MEMORANDUM

Subject: **Proposed Mixed-Use Residential, Commercial, and Parking Development at 622 Graceland Avenue and 1332-1368 Webford Avenue:**
Consideration of a Combined Tentative and Final Plat of Subdivision

Case Number: 23-005-FPLAT

TENTATIVE AND FINAL PLAT OF SUBDIVISION GRACELAND/WEBFORD SUBDIVISION

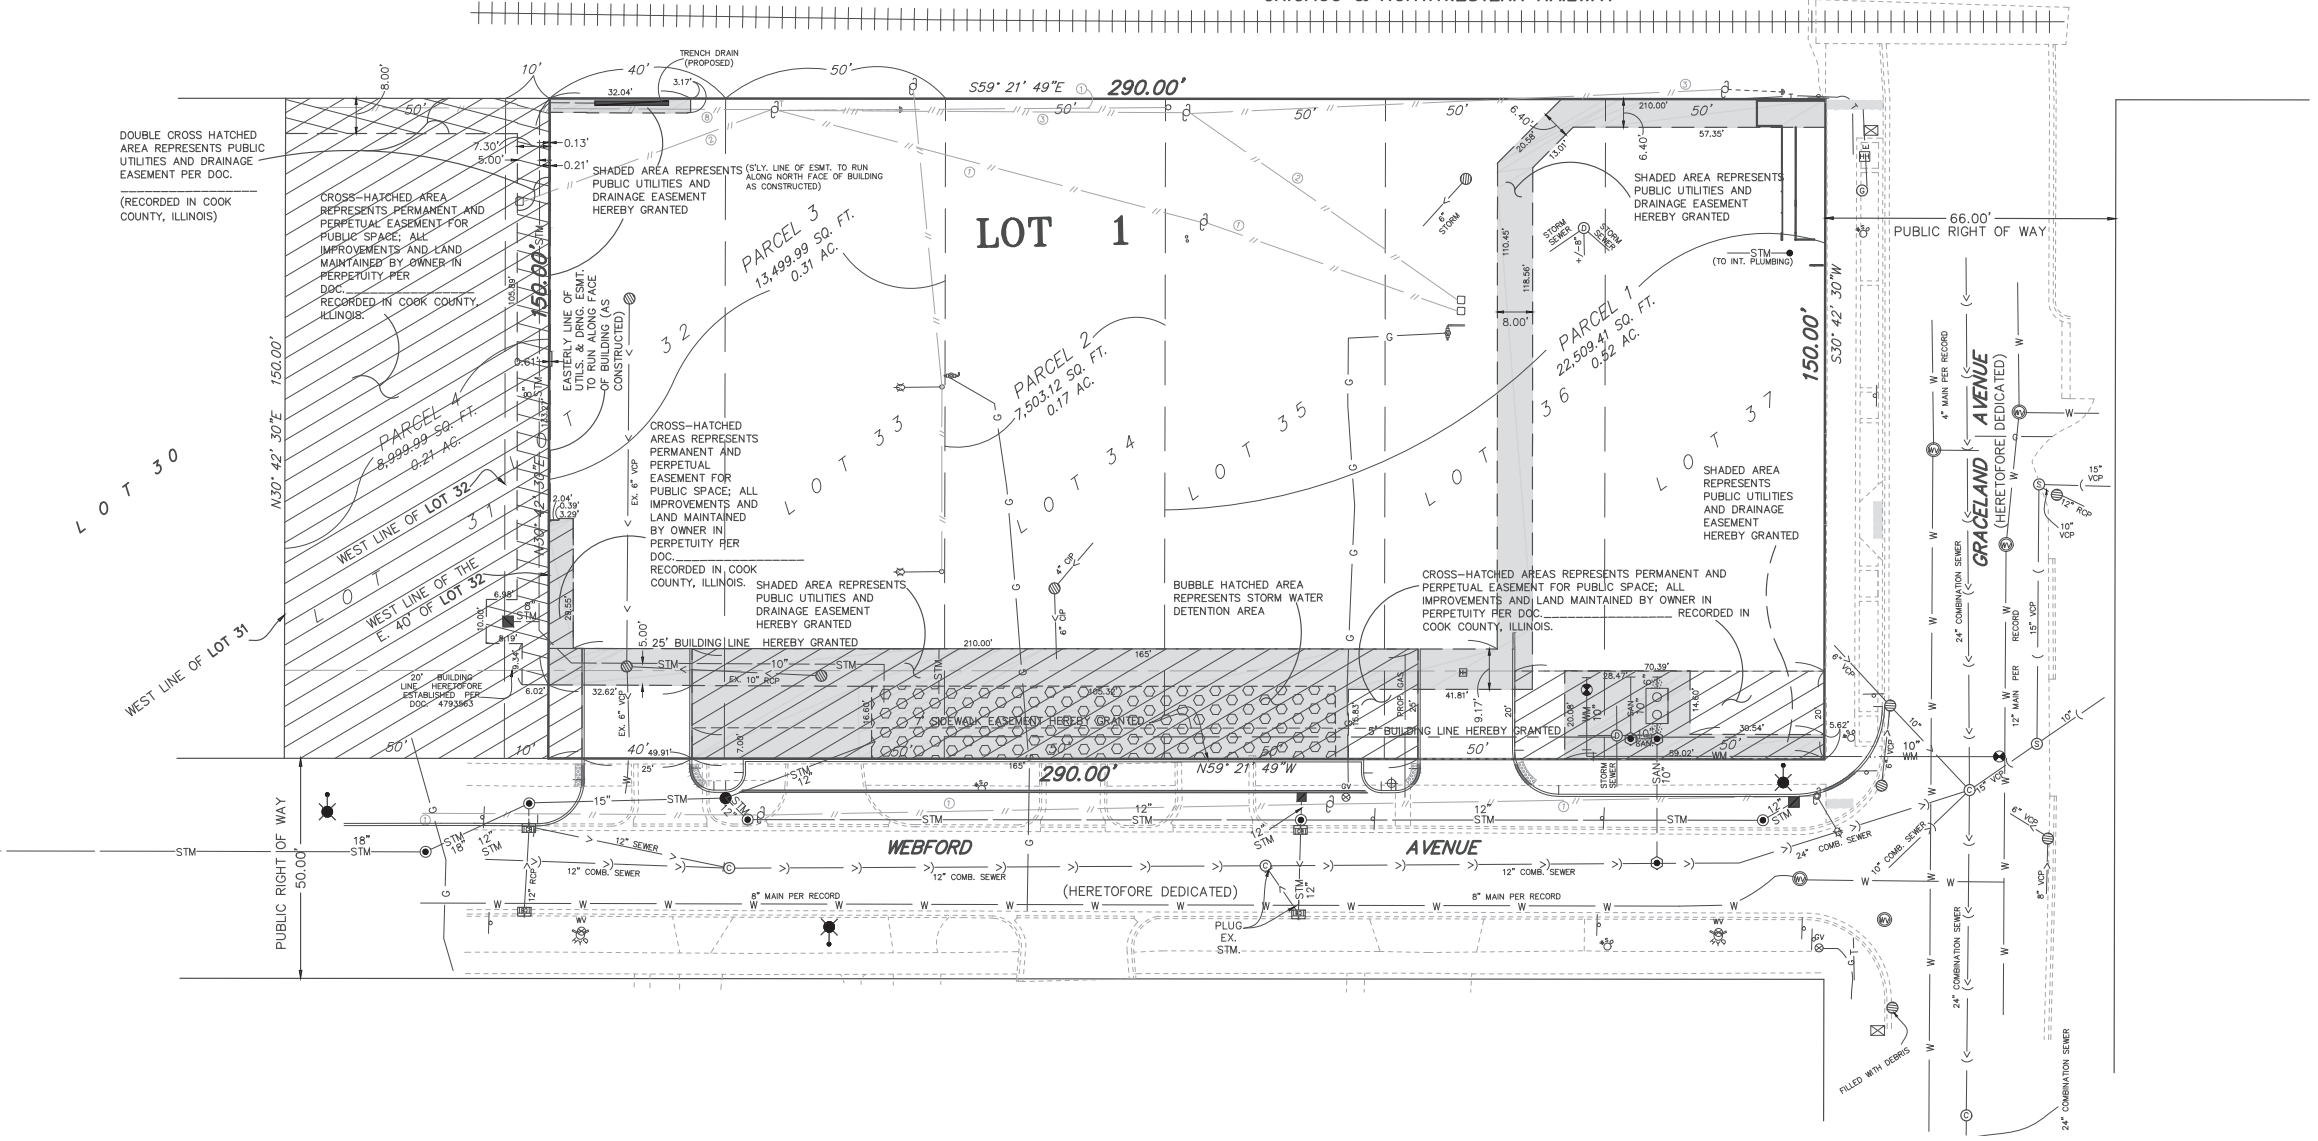
NO.	DATE	REVISION DESCRIPTION	BY
4	3/03/23	PER 3/02/23 CITY REVIEW DISCUSSION	VAF
3	2/23/23	ADD P.U. & D. AND PARK ESMTS; UTIL SIG. BLKS.	VAF
2	2/1/23	REMOVE PARCEL 4 FROM SUBD. INCLUSION	VAF
1	1/13/23	PER 12/20/22 QTY 1ST REVIEW COMMENTS	VAF
